CITY OF ALBUQUERQUE

RE: 8500 Glendale Ave NE
Grading and Drainage Plan
Engineer's Stamp Date: 11/10/18
Hydrology File: B20D067

Now onto the on November 13, 2018 submittal for Building Permit, based upon the information provided this Grading Plan **is not** approved for Building Permit. The following comments need to be addressed for approval of the above referenced project:

ENGINEER'S SEAL 11/10/18 DAVID SOULE P.E. #14522	8500 GLENDALE AVE.	DRAWN BY DEM
	GRADING AND DRAINAGE PLAN	DATE 11-9-18
	 Rio Grande Engineering 1808 CENTRAL AVENUE SUITE 201 ALBUQUERQUE, NM 87108 (505) 872-0888	LOT 5, BLOCK 17 ON 3 INJUNCTION
		SHEET # 1 OF 1
		JOB # XXXXX

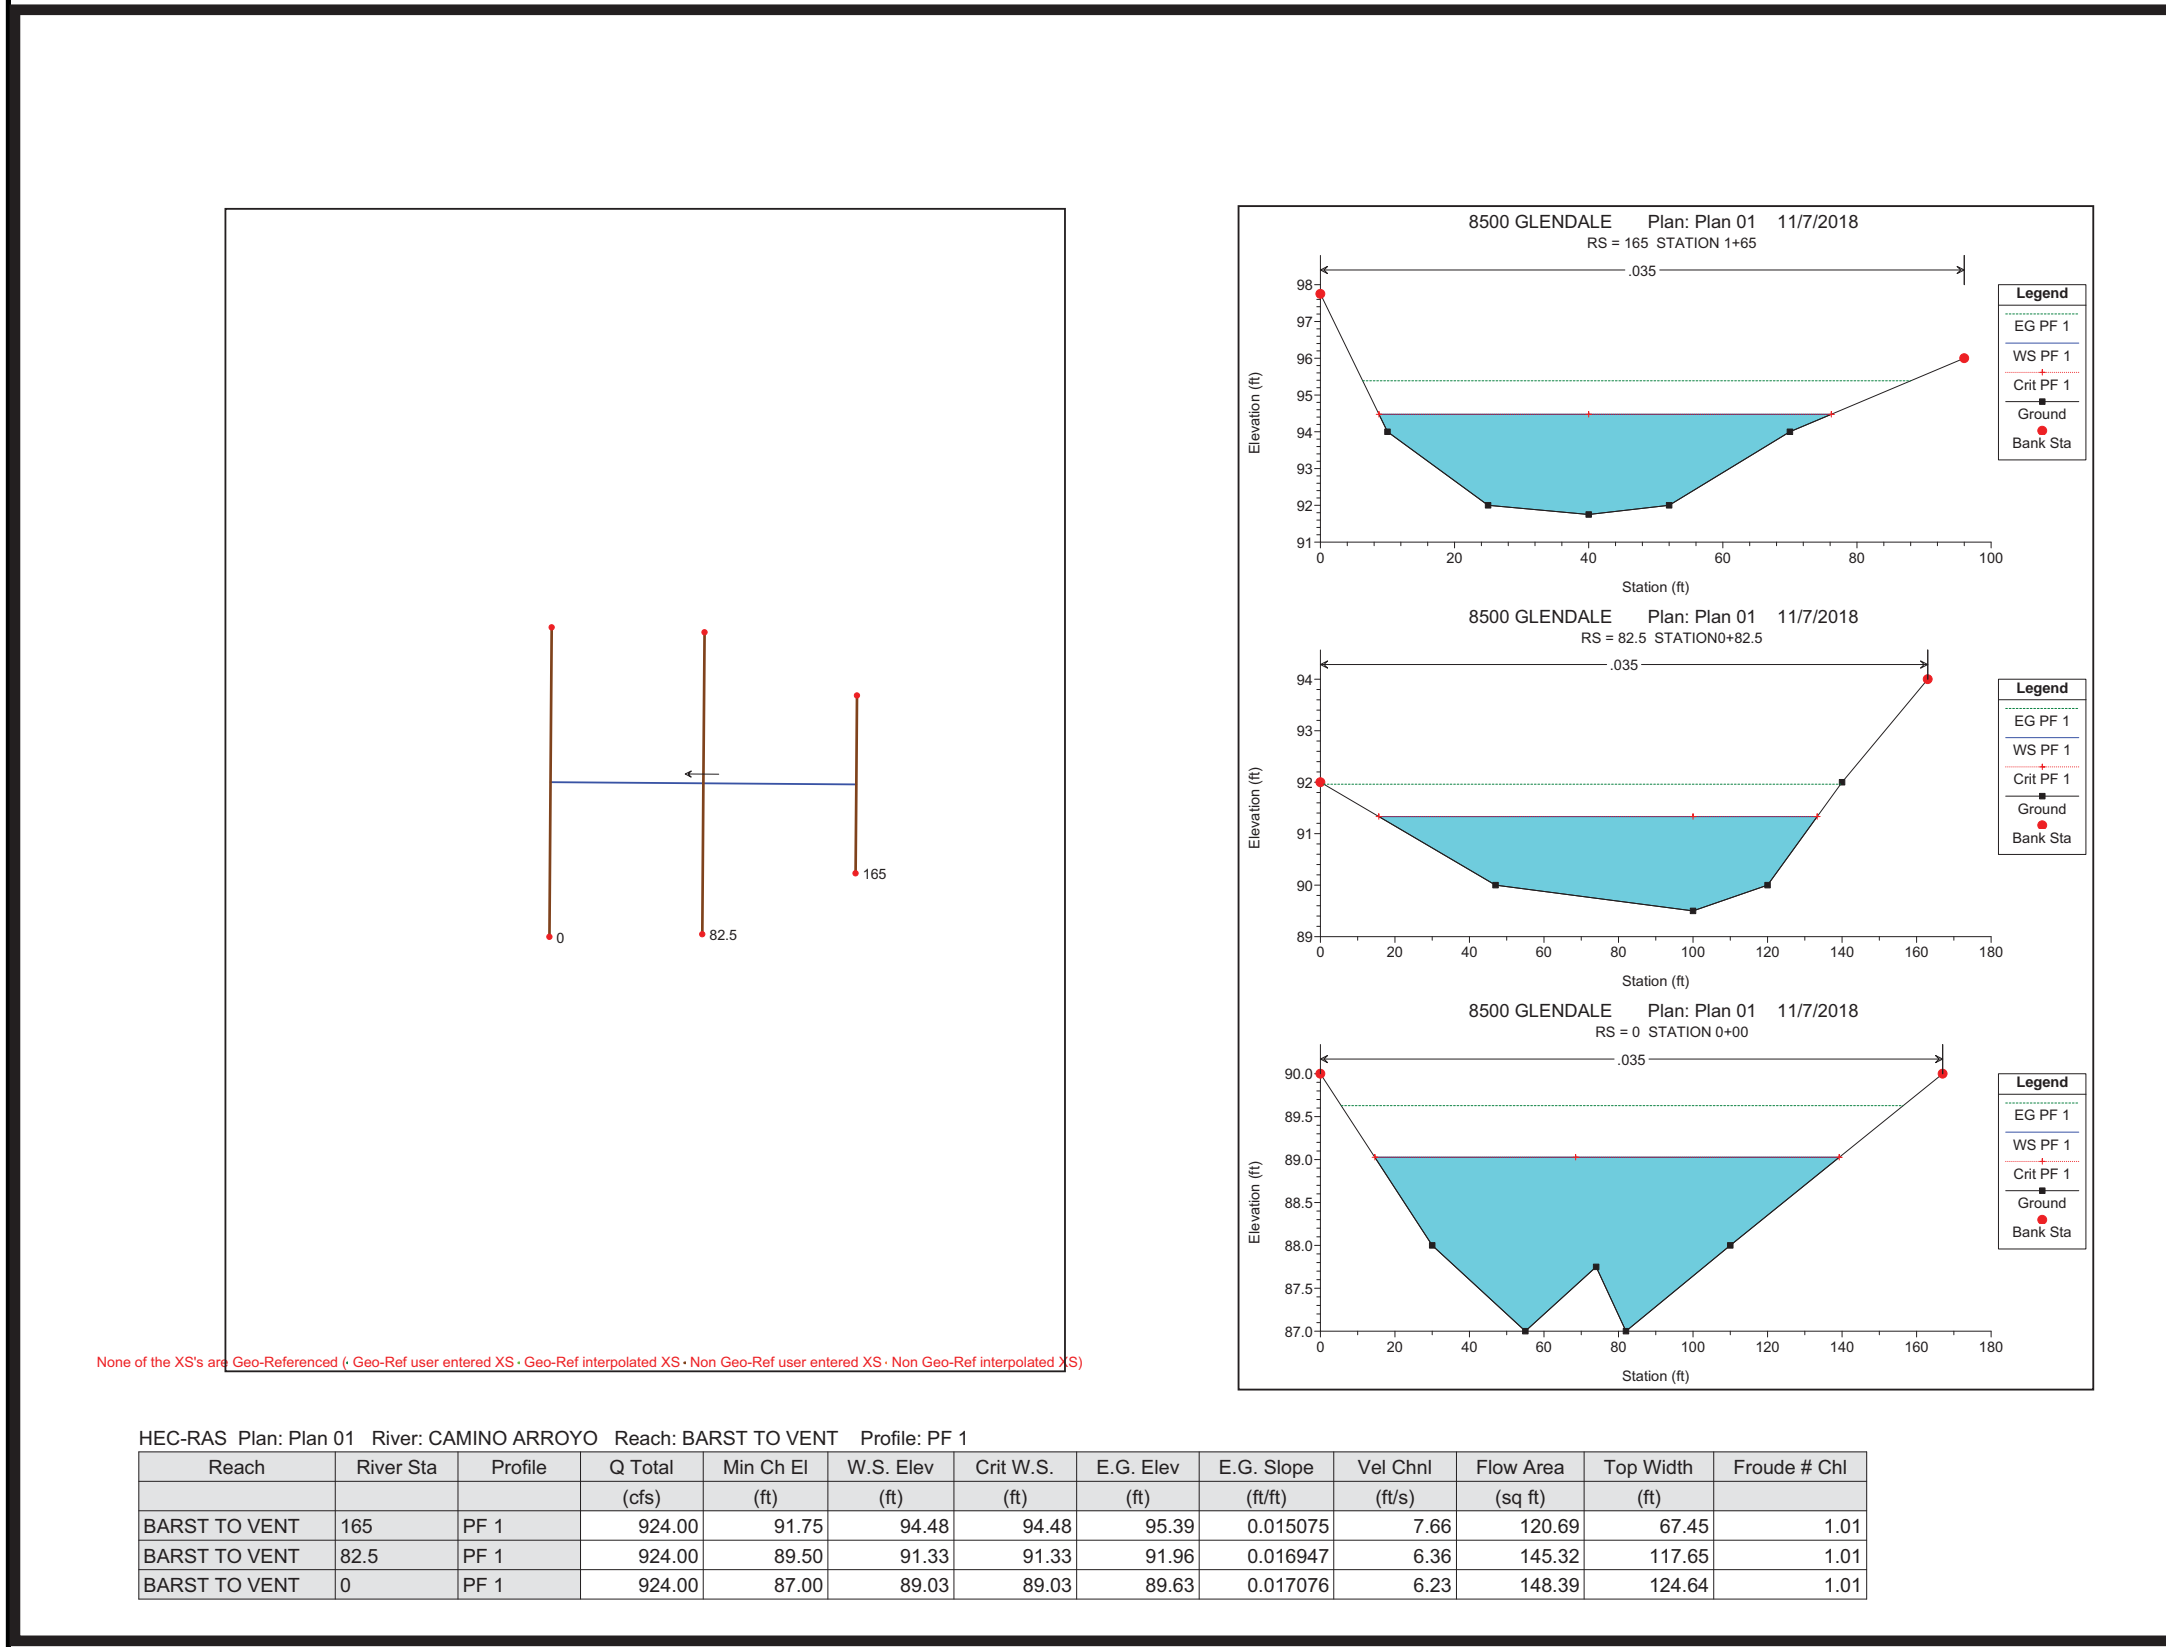
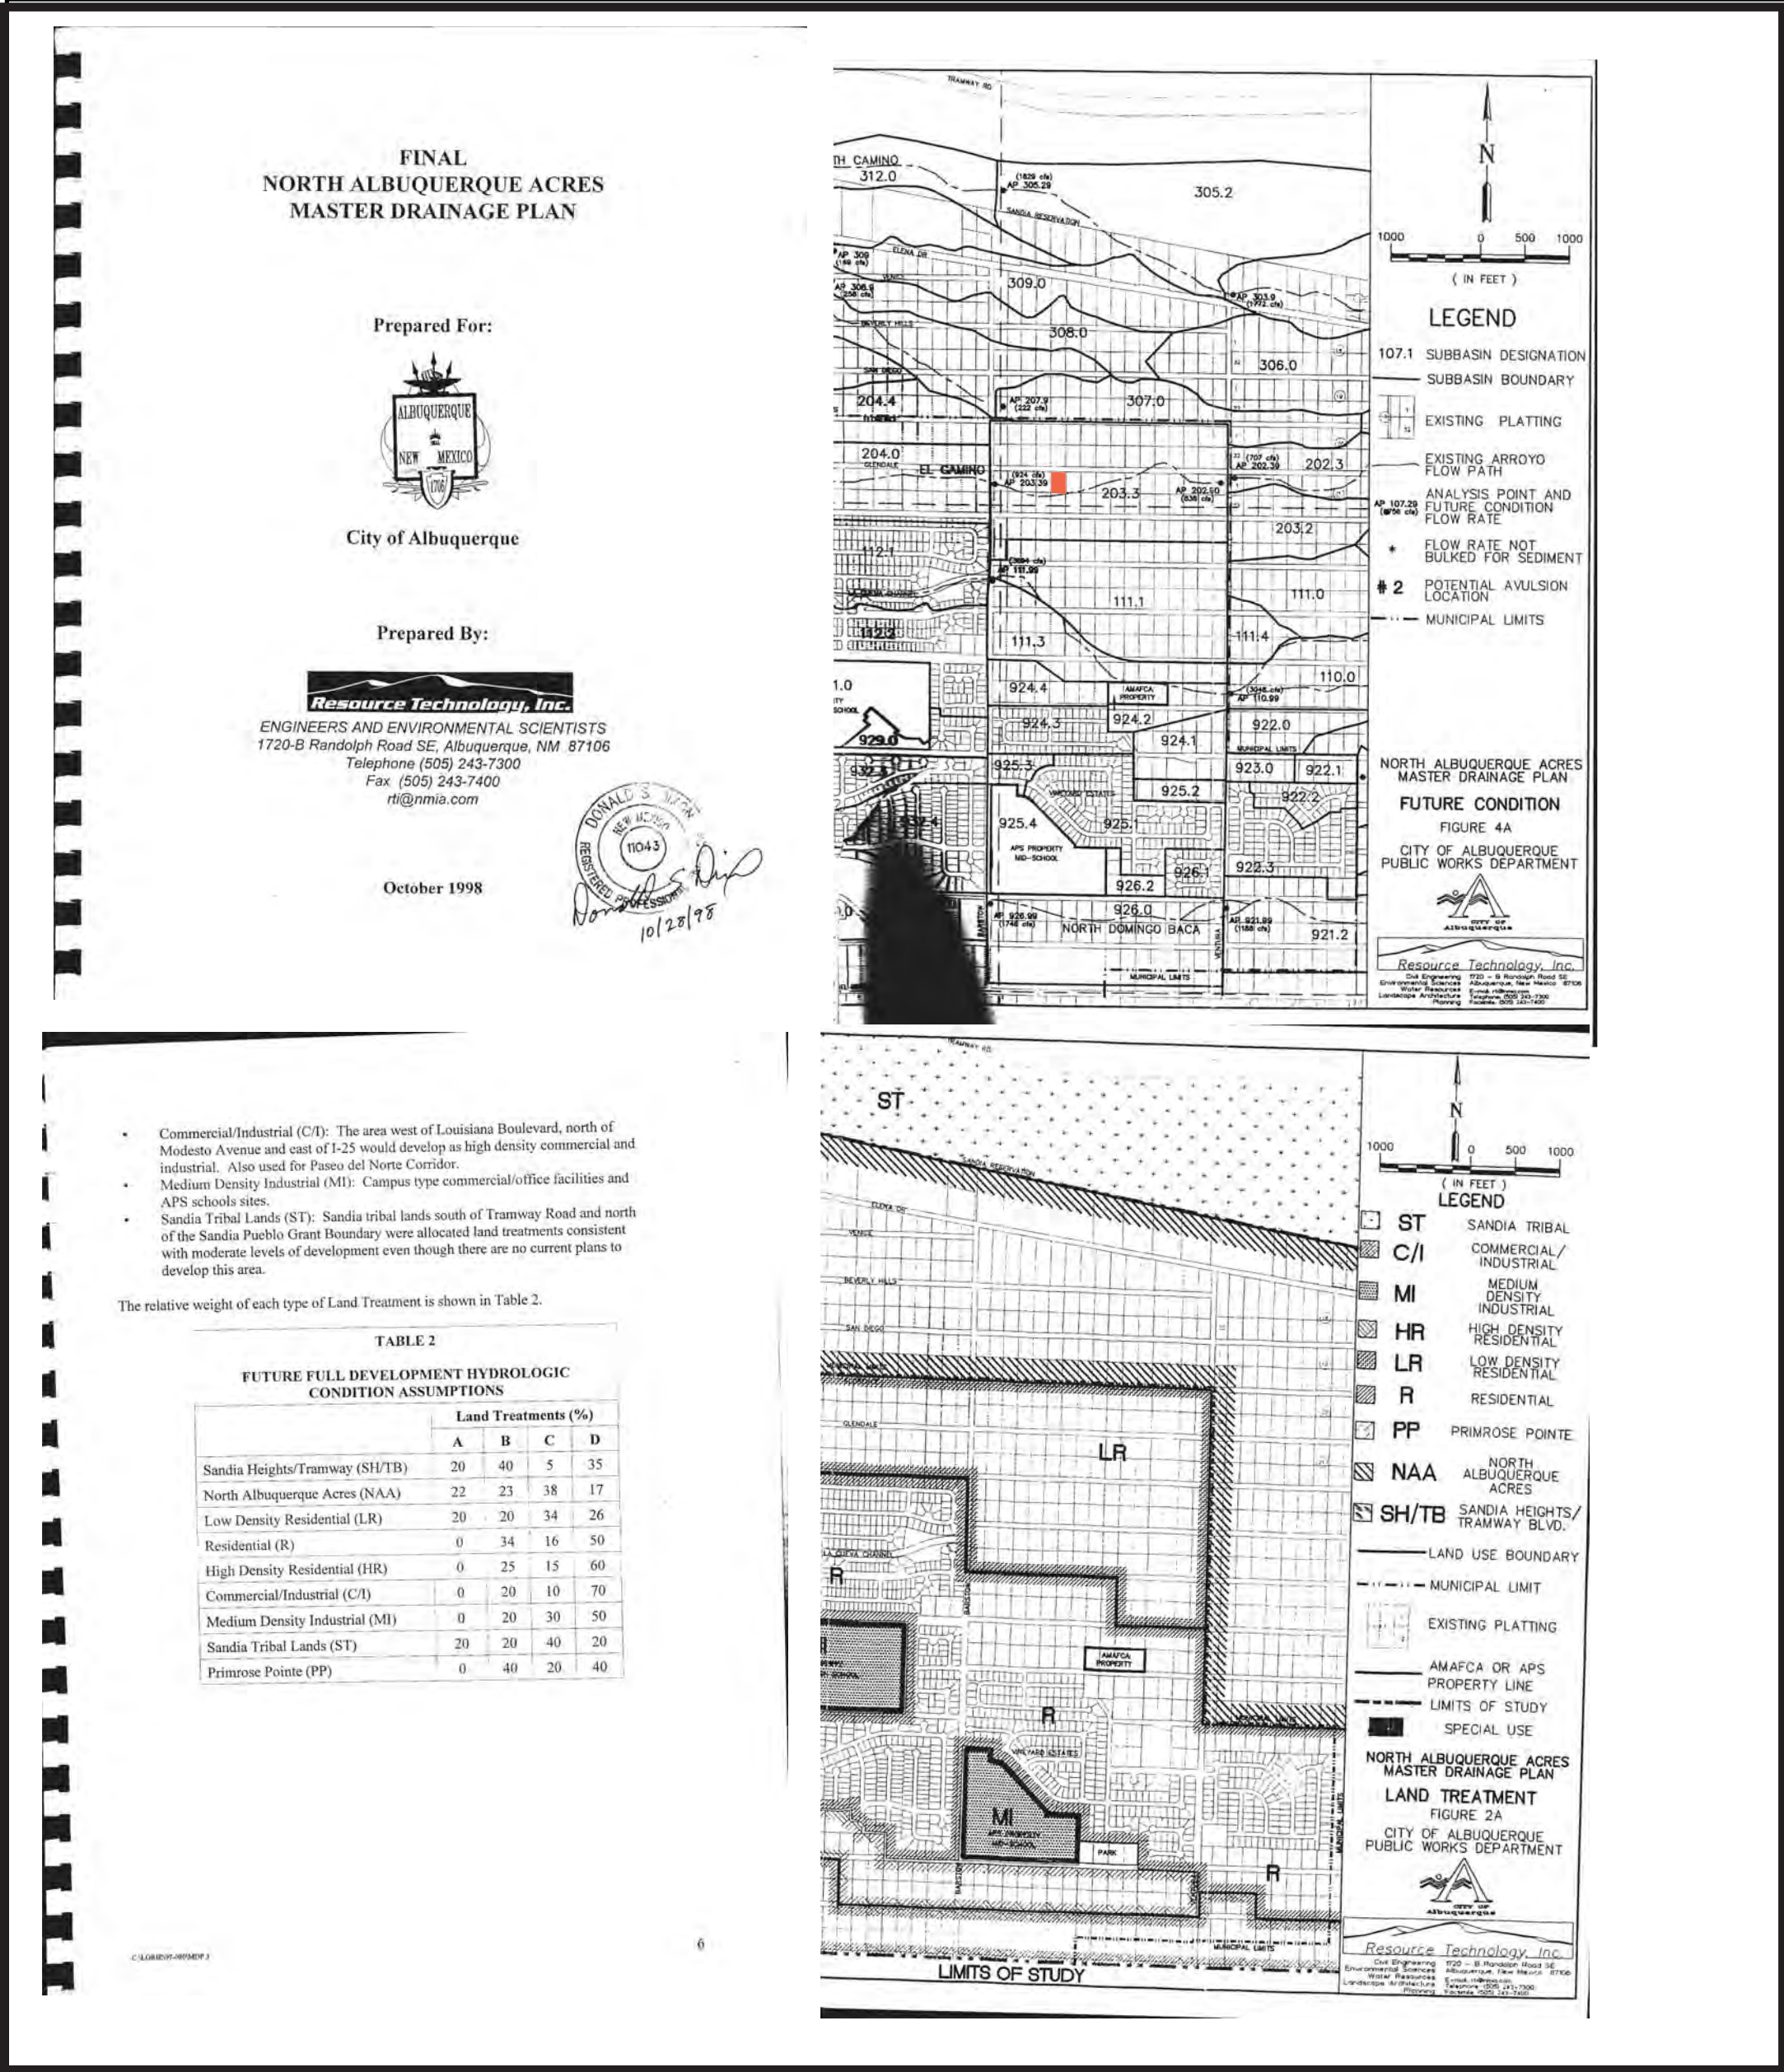
1. Per the IDO § 6-4(Q), the property owner of the property is responsible for building the adjacent half of Glendale Ave to include curb & gutter, sidewalk, and 84" storm sewer per the North Albuquerque Acer Master Drainage Plan. The plan will have to go to the DRB for approval of the Infrastructure List which will have to financially guaranteed.

2. Please add a drainage easement along the 100 year floodplain line granted to the City. The Permanent Easement form can be obtained at the Hydrology Section's webpage. <https://www.cabq.gov/planning/development-review-services/hydrology-section>

3. Please clarify the finished floor elevation and finished pad elevation. They are currently over the existing grade text and it is difficult to read.

4. Please provide the sections and structural calculations of the scour walls.
5. Please clarify the placement of the leader for the turn 4 blocks @ 5493.00 near the southwest corner of the property. It is currently pointing in the arroyo and not the scour wall.

6. Please provide an additional scour depth equation (3.90 in the Sediment and Erosion Design Guide) for flows at a 90° to the scour wall. The current scour depth equation is only good for flows parallel to the scour wall. This will increase the scour wall depth in the areas where flows are at 90° to it.
